Service Bulletin

SUBJECT: Special Coverage Adjustment – Negative Battery Cable Loose

MODELS: 2011-2015 Chevrolet Cruze

Subject: 14311B – Special Coverage Adjustment
Negative Battery Cable Loose
Revised Warranty Transaction Information Section

4002405

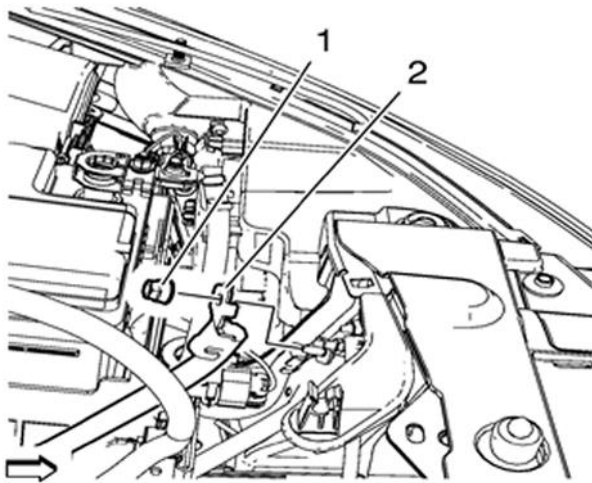
13. Before installing the negative cable and starter ground cable to the G100 ground stud, measure the length of the stud. The information below will provide direction as to the correct nut to use for attachment

- The shorter ground stud (17mm) WILL NOT accommodate the original nut (2) which was removed from the stud. Replace the nut with either the shorter nut (1) which was removed from the ground connection at the battery terminal (and not reused on the new cable design) or obtain GM P/N 11561645.
- For the longer ground stud (23mm), the original nut (2) can be reused.
